# **ADDENDUM NO. 3**

# TRACK & FIELD IMPROVEMENTS - INC 1

# **Pacifica High School**

December 3, 2019

PULLBOX MOUNTING DETAIL SCALE: NONE

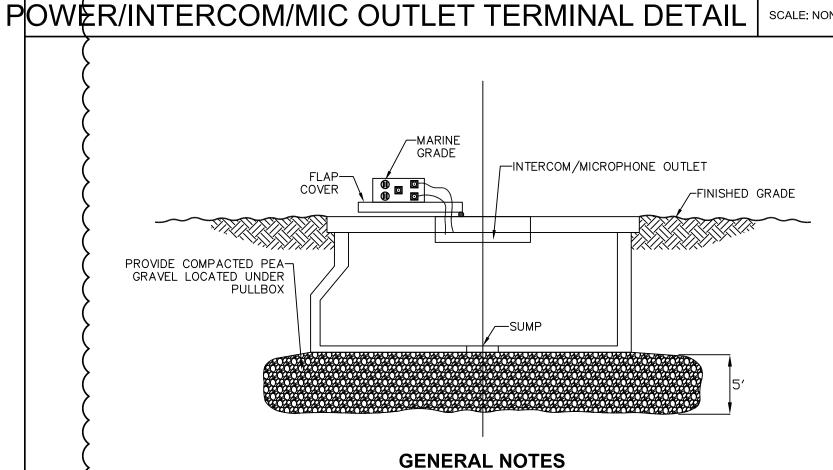
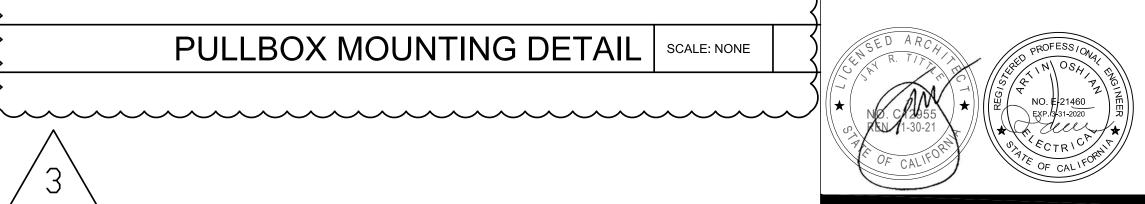
- 1. THE TRACK SURFACE MATERIAL SHALL COVER PULLBOX COVER AND LID.
- 2. ALL PULLBOXES NEAR TYRACK SHALL BELOCATED ON EDGE OF TRACK.

- 1. THE TRACK SURFACE MATERIAL SHALL COVER PULLBOX COVER AND LID.
- 2. ALL PULLBOXES NEAR TRACK SHALL BE LOCATED ON EDGE OF TRACK.

(E-000) AD3-E1

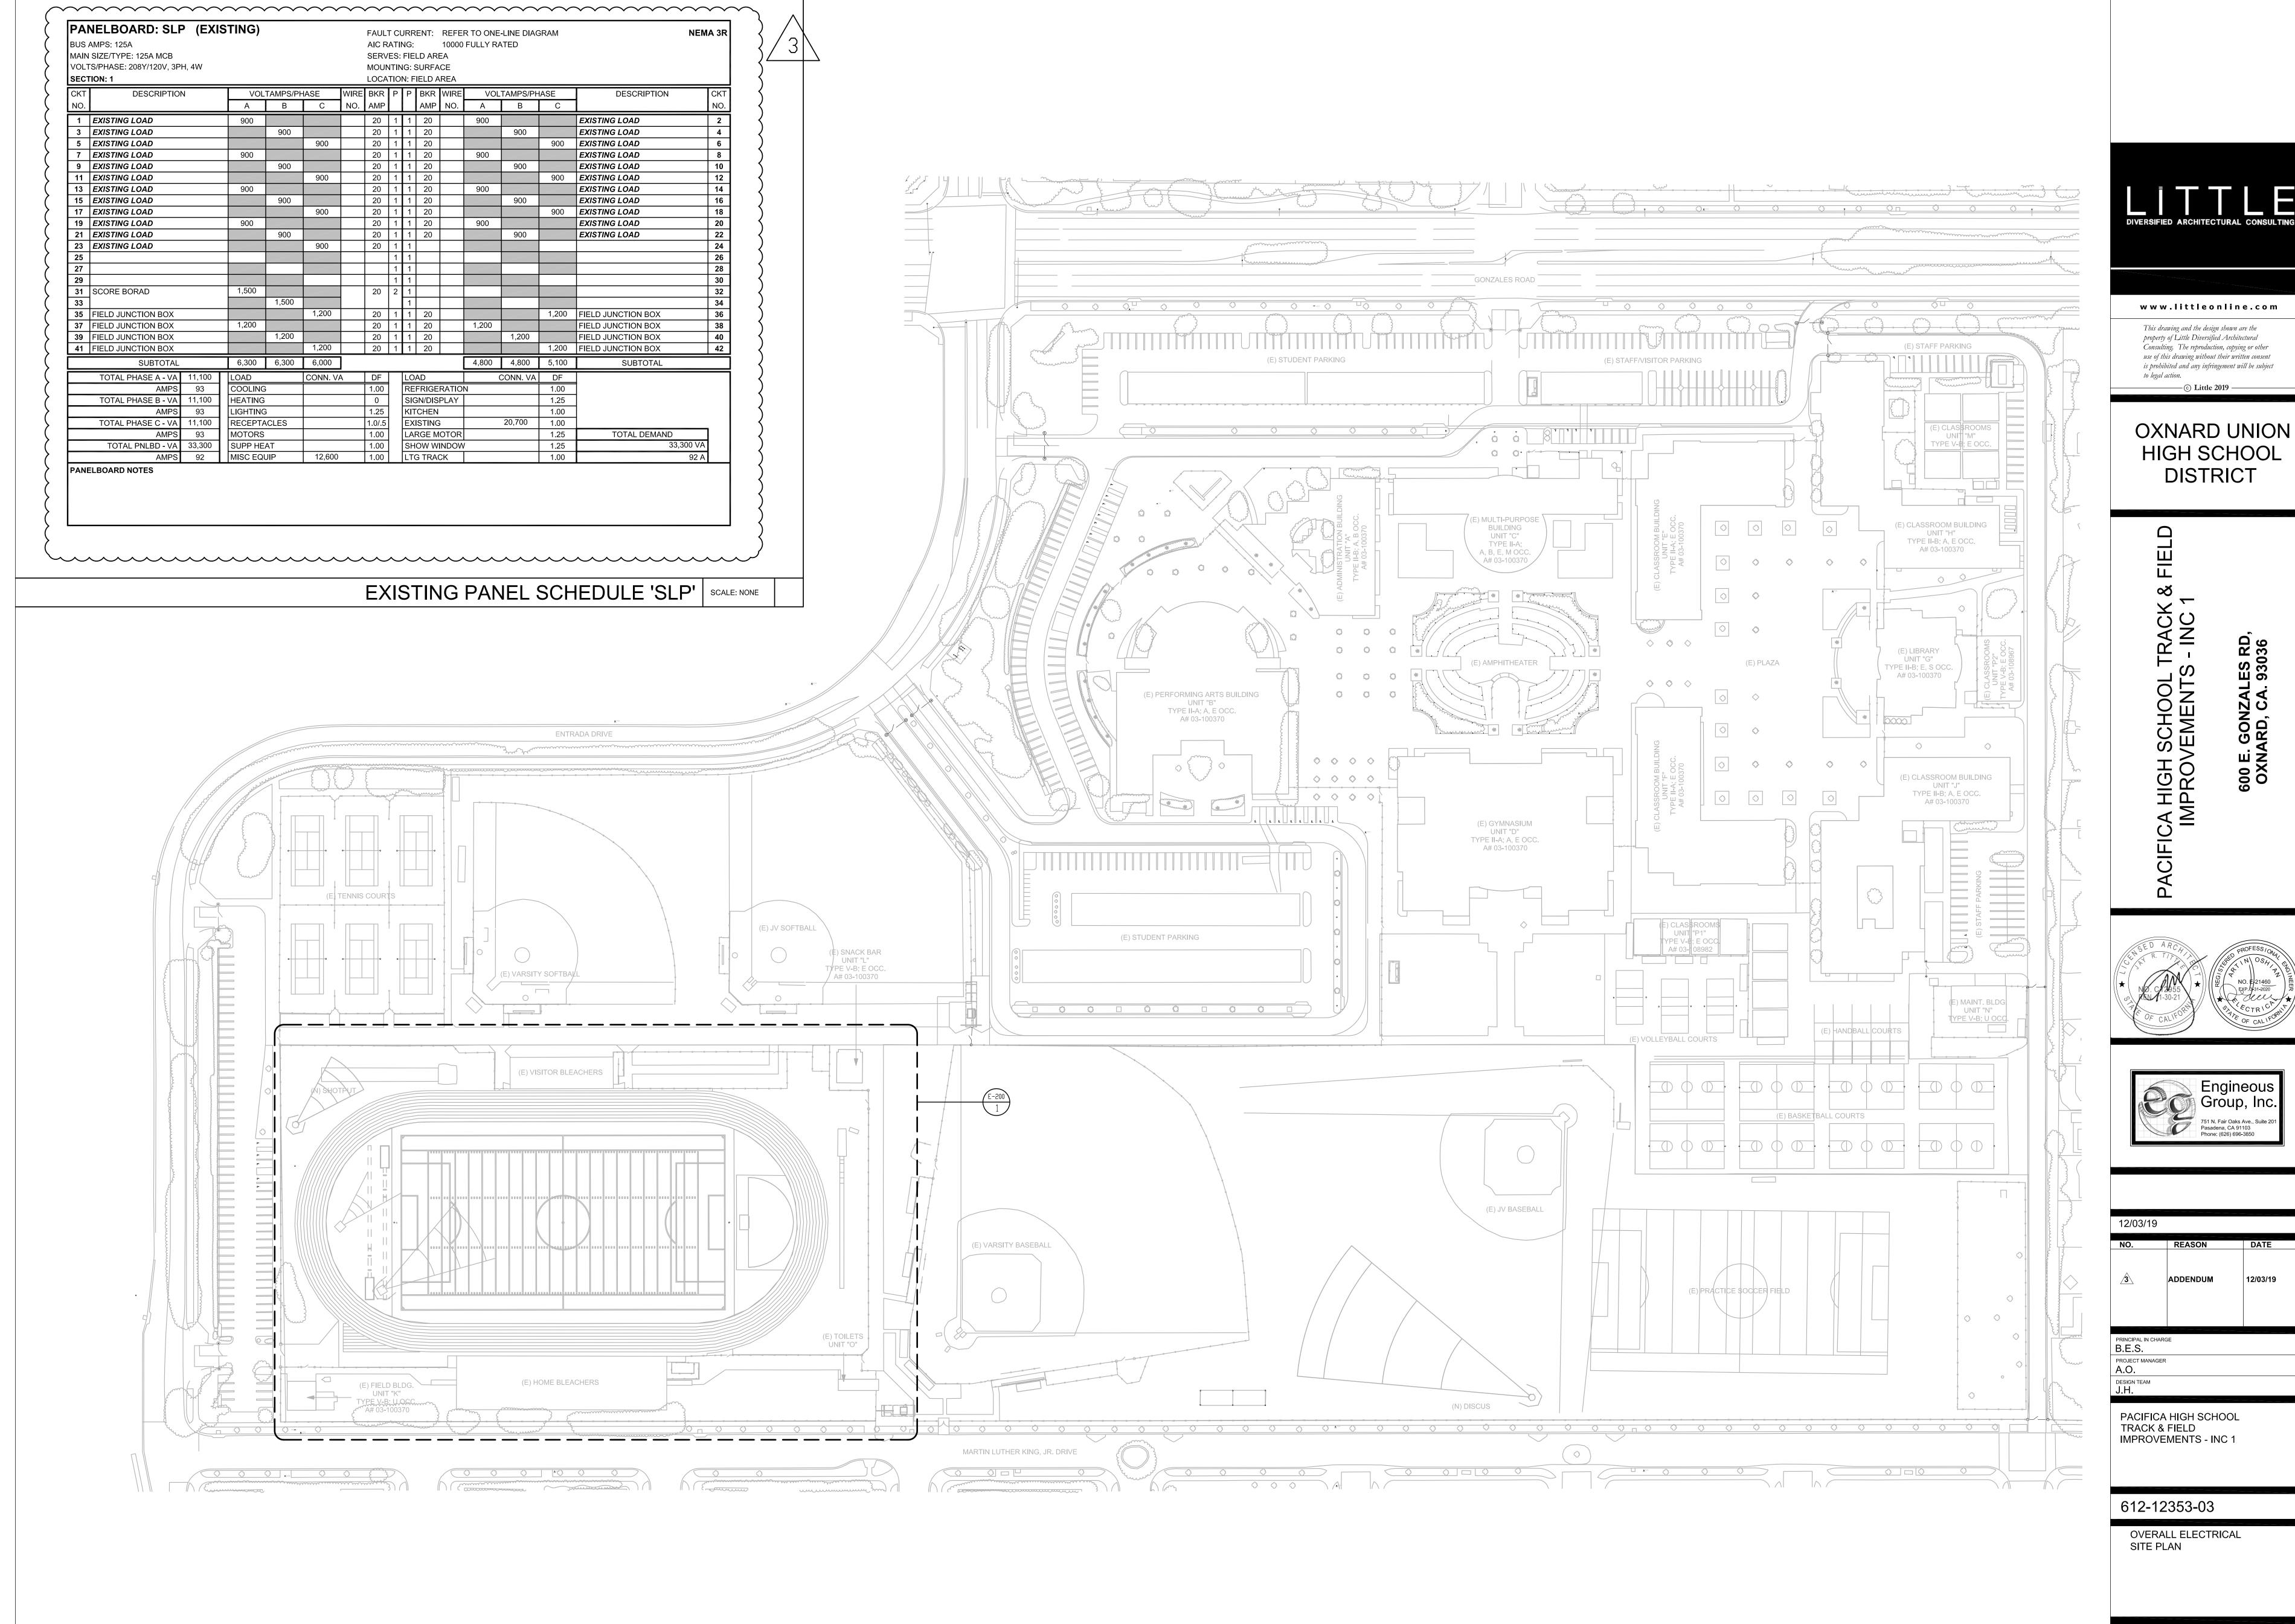
- **3.2.2.1.** Drawings E-000/AD3-E1, E-100/AD3-E2, E-200/AD3-E3 Clarify as follows:
      - **3.2.2.1.1.** New and existing panels and electrical equipment are shown on sheet E-100 (AD3-E2) & E-200 (AD3-E3).

- **3.2.2.1.2.** Refer to note P2 on sheet E-200 (AD3-E3) for proposed minimum sizing of the junction boxes. Also, refer to sheet AD3-E1 and AD3-E3 for quantity & size of conduit connected to each junction box to determine box size at each location.
